Re: Source Materials License SUA-1534
Docket No. 40-8943
Mine Unit 1 Restoration; Response to Request For Additional Information

**Crow Butte Resources, Inc.
Response to U.S. Nuclear Regulatory Commission
Request For Additional Information**

Mine Unit 1 Groundwater Restoration Completion

Crow Butte Uranium Project

Appendix C. Iso-Concentration Maps for Selected Parameters

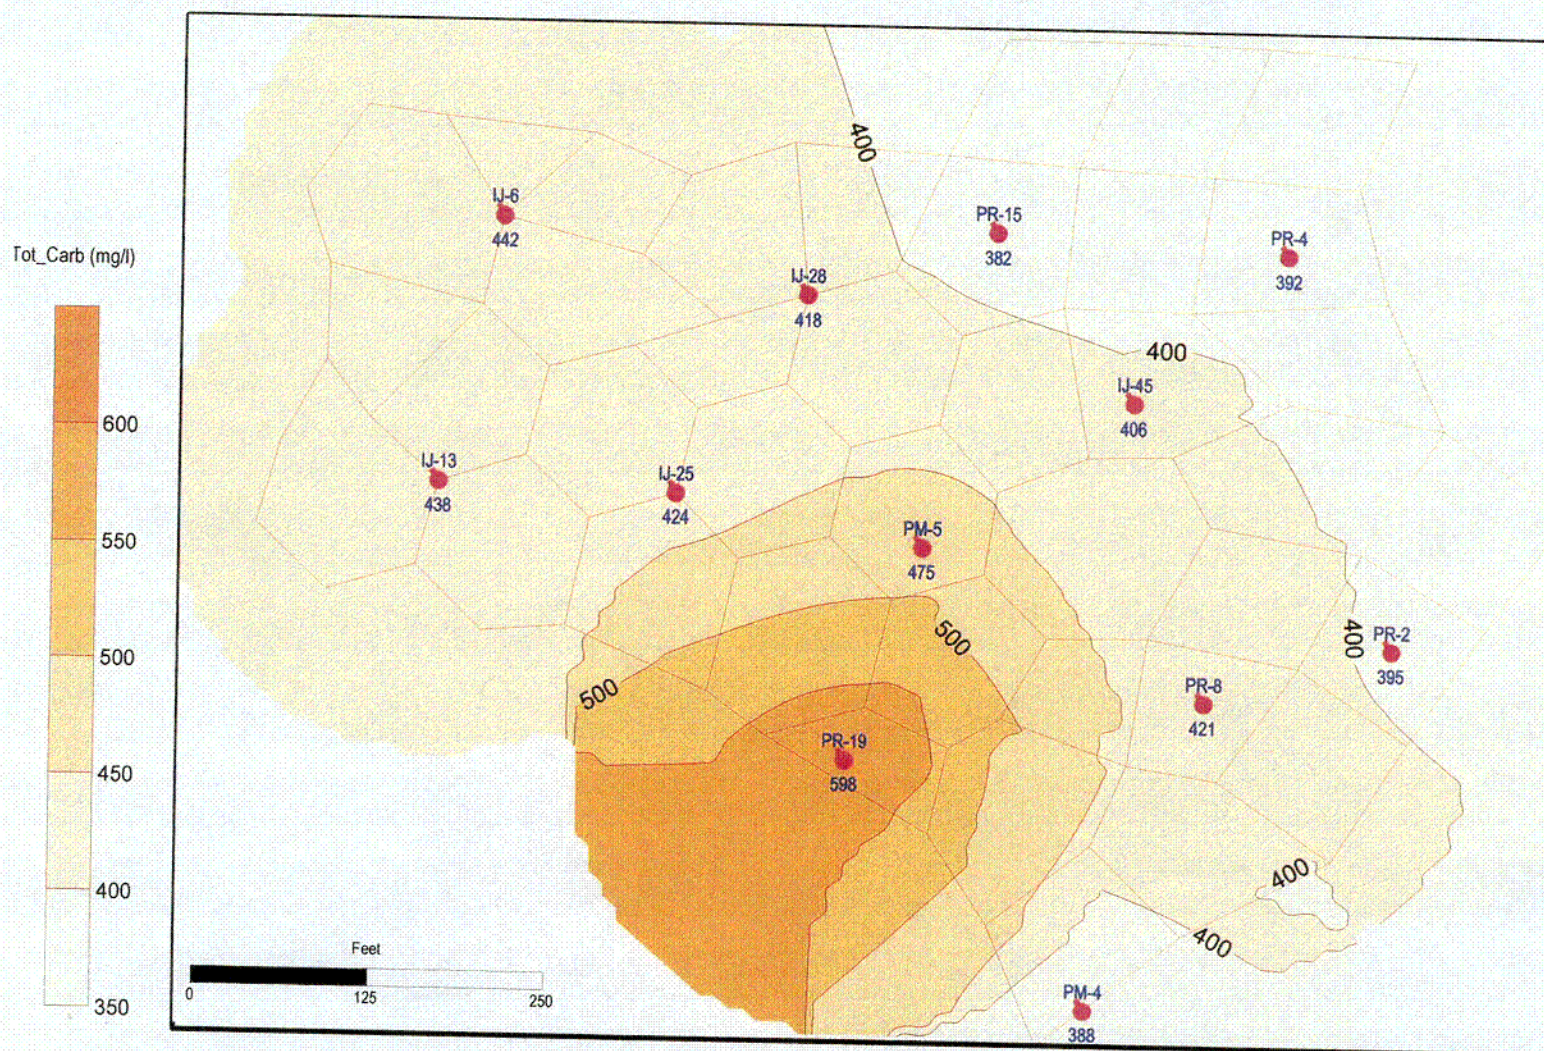
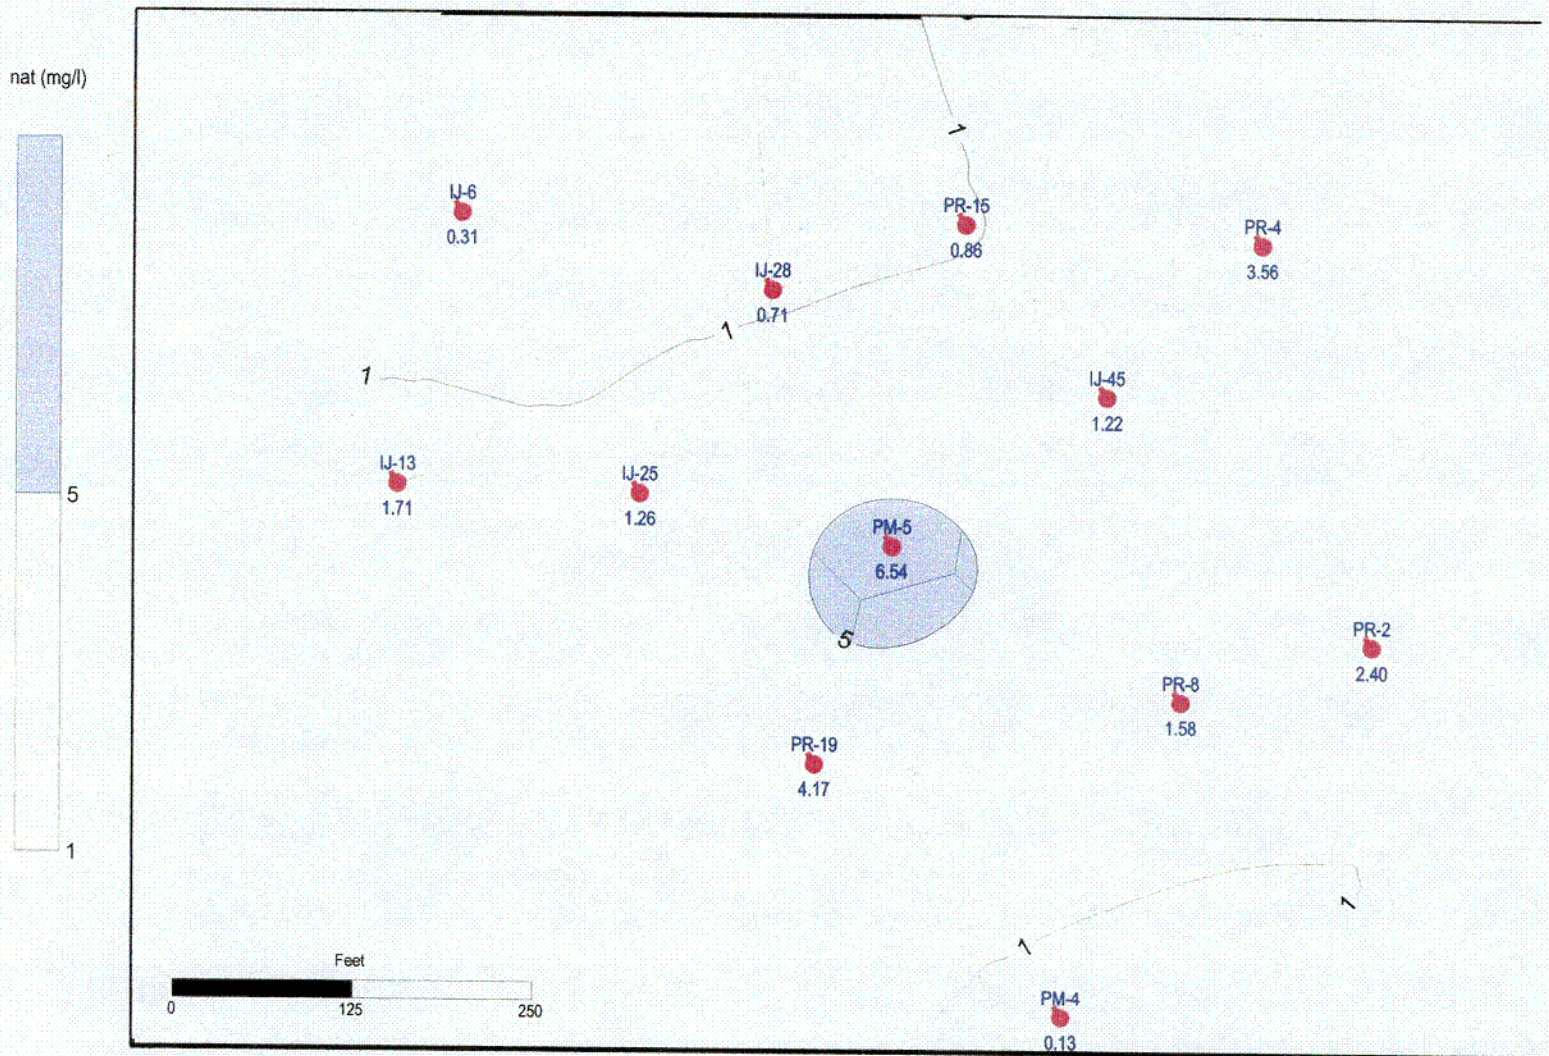
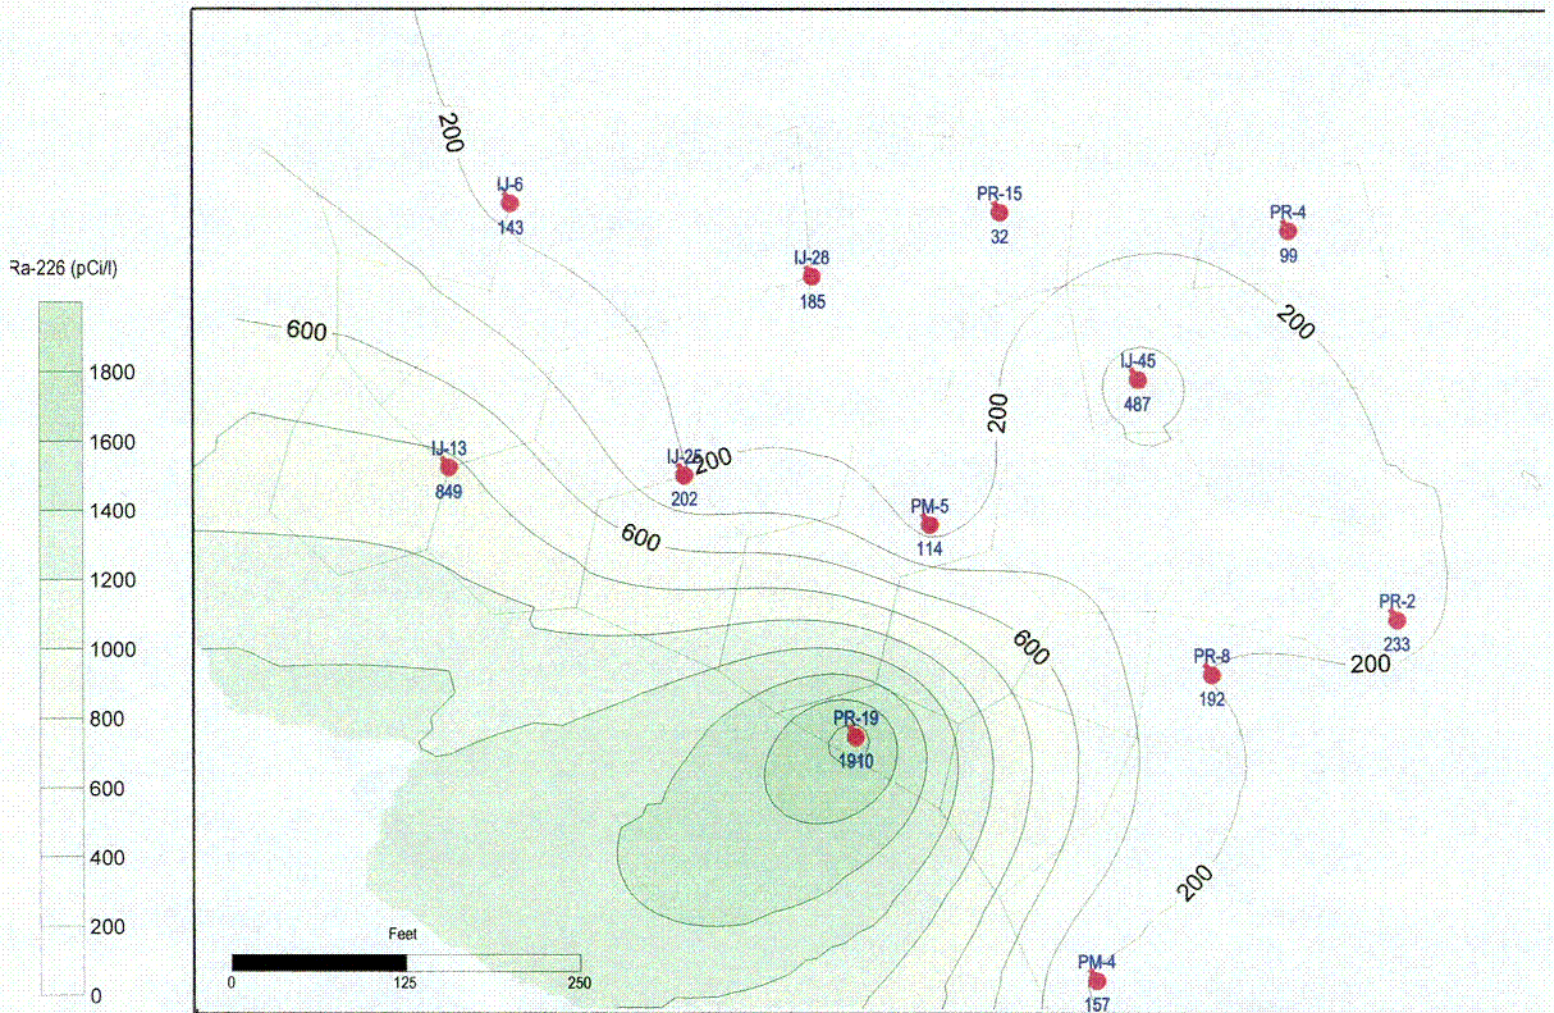
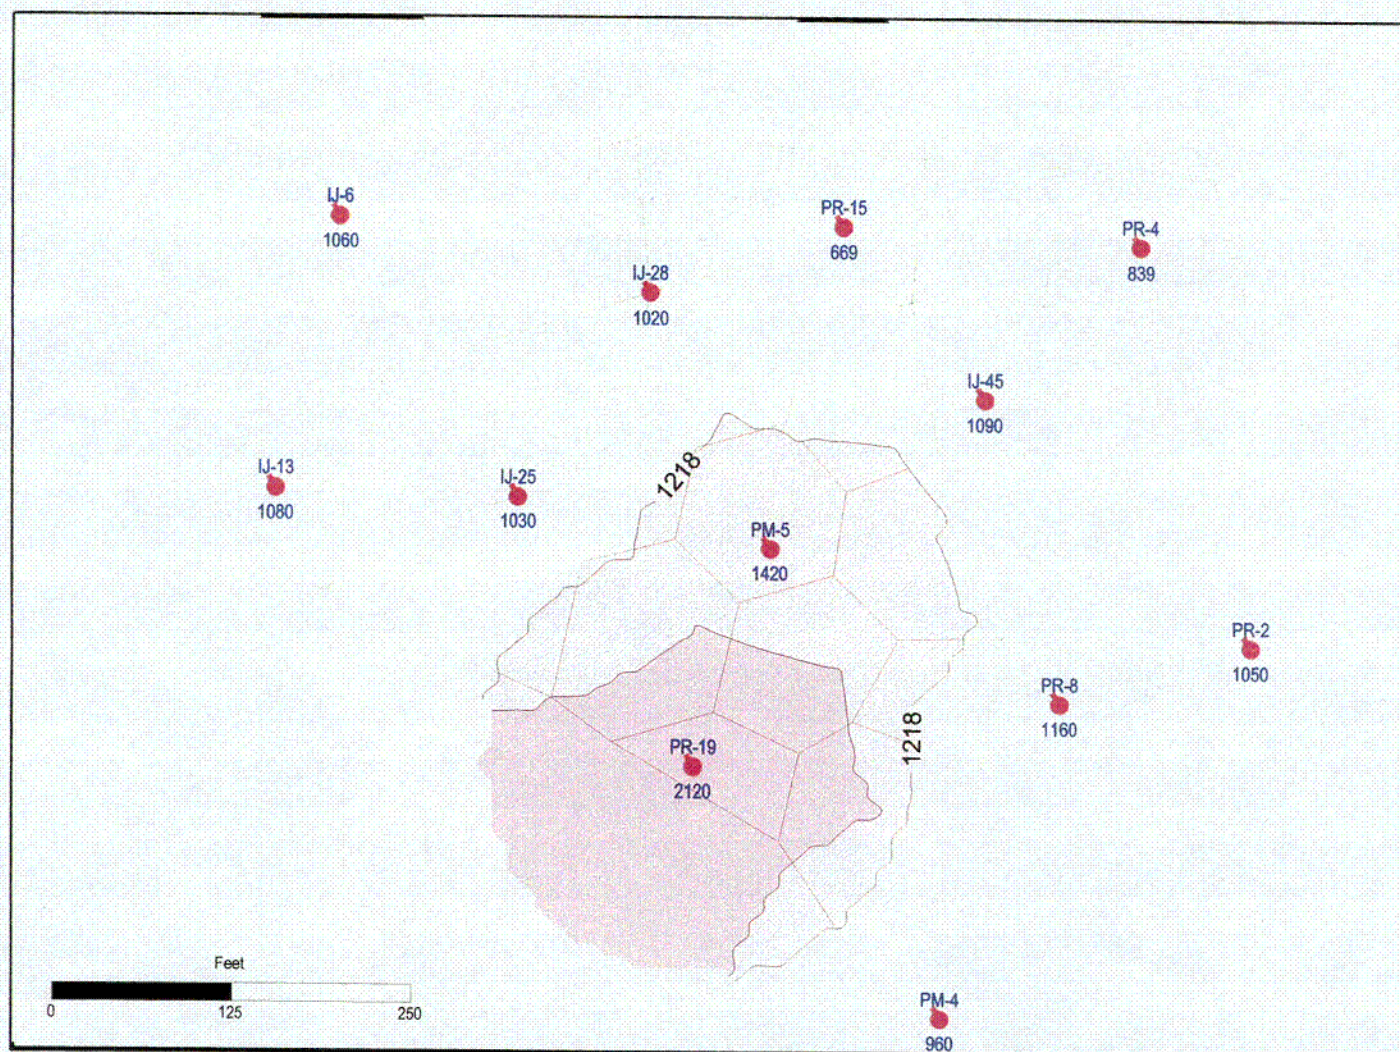
NRC requested that CBR submit iso-concentration maps for radium-226, natural uranium, total dissolved solids, and total carbonate in the Mine Unit 1 restoration and perimeter monitor wells, once the restoration is stable. As discussed in Section 3.2.2, CBR believes that the data indicates that the restoration was stable during the stabilization phase. Therefore, iso-concentration maps have been prepared from the stabilization period monitoring data.

Appendix C contains the iso-concentration maps for the parameters requested. The maps were developed from the final data set collected on July 15, 1999 from the Mine Unit 1 Baseline Restoration Wells. Data from the Mine Unit 1 perimeter monitor wells (CM1-Wells) was not used to prepare these maps as requested in the Request for Additional Information. As explained in Section 3.2 of the restoration report, these wells were no longer in service as monitor wells on that date. During the expansion of mining operations, the CM1-Wells were incorporated into neighboring mine units. Therefore, data collected from these wells would not be relative to the groundwater quality in Mine Unit 1 following restoration. The successive removal of these wells as active perimeter monitor wells was approved by NRC in the Notices of Intent to Operate for Mine Units 2, 3 and 4.

When reviewing these maps, it is important to keep in mind the limitations of the gridding programs, and the nature of the parameters being modeled. These iso-concentration maps were generated using a linear Kriging gridding method within the contouring program, Surfer (published by Golden Software, Golden, Colorado). This method produces a regularly spaced, rectangular array of concentration values collected from the Baseline Restoration Wells. These wells are not evenly spaced over the wellfield area, which leads to missing data in the grid pattern. The gridding method interpolates concentration values where no data exists. Therefore, the contours extending beyond the boundaries of the wellfield represent an interpretation by the gridding program where there is no data.

As mentioned above, the gridding program can only produce a grid map from the data provided. The gridding program does not recognize the geochemical reactions that take place between the groundwater and the host formation. This is another limitation associated with the gridding program. As an example, the iso-concentration map produced for radium-226 generates high concentration contours some distance beyond the southwest boundary of Mine Unit 1. However, due to the strong sorption affinity of radium-226, it is unlikely that these extrapolated concentration levels present an accurate representation of the radium-226 concentrations in that area. It has been documented at numerous uranium mine and tailings disposal sites that radium-226 does not migrate a significant distance from its source.
